SERVICE LETTER No. L 136-Rev.4

MODEL AFFECTED: Z 242 L aircraft, S/N: 0682, S/N 0685, S/N 0745

SUBJECT: Aircraft manufacturer instructions for detected cracks and defects and repair instructions.

Fig. No. 1 (S/N 0682)

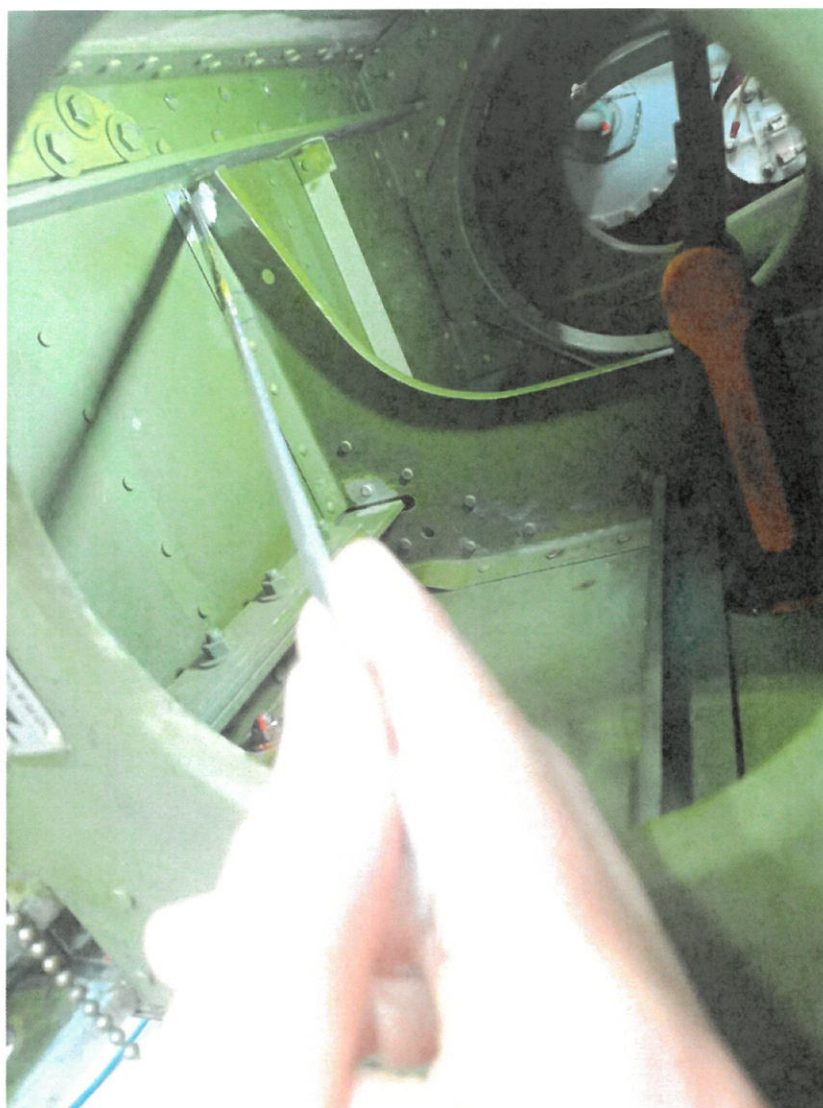
- 1) Second rib from both the left- and right-wing root. The length of the cracks is 4, resp. 2 mm (see Fig. 1 and 1A and No. 2).

1. Repair the rib cracks as described on pages 4-17 and 4-33 of the above-mentioned document. The final state of the repaired rib is as follows:

Fig. No. 4 (S/N 0682)

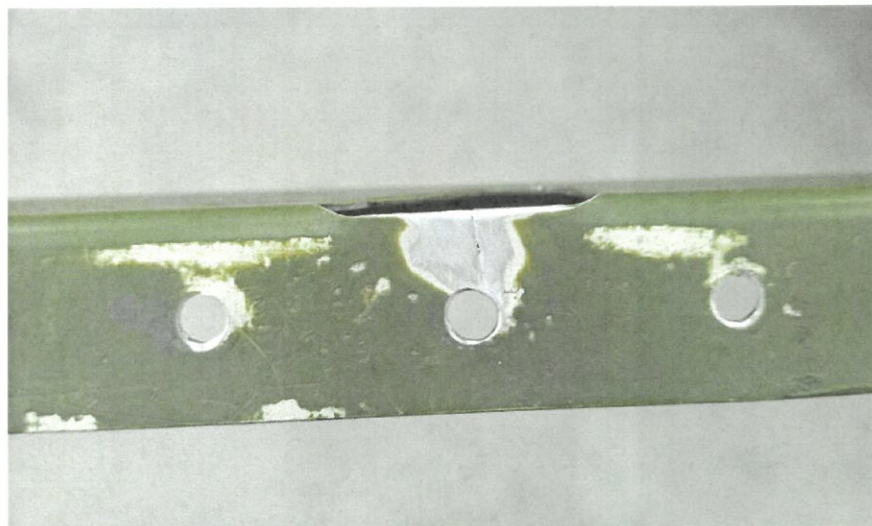
- 2) The rear part of the left root rib. The length of the crack is 3 mm (see Fig. No. 3 and No. 4.

- 2) Repair the rib cracks as described on pages 4-17, 4-30 and 4-37 of the above mentioned document. The final state of the repaired rib is as follows:

Fig. No. 5 (S/N 0682)

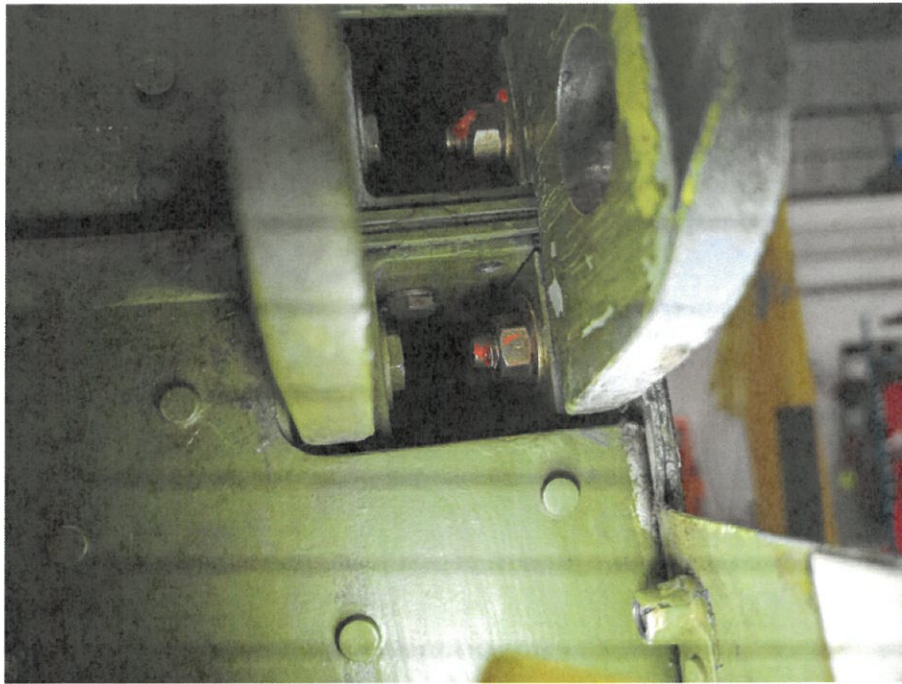
- 3) The sheared head of the technological rivet connecting the lower and upper plate of the main wing attachment point was found (see Fig. No. 5 and No. 6.).

- 3) Replace the sheared rivet by the bolt as described in Service Bulletin Z242L/20a issued by ZLIN AIRCRAFT a.s. on 6th June 1996.
The rivet replacement for the screw must be performed on both wing attachments.

- 1), 2) provided by the operator
- 3) the bolt M5x20 ONL 3120.24 together with washers 5,3 ČSN 02 1702.14 and nut M5 ONL 3247 will be provided by the airplane manufacturer
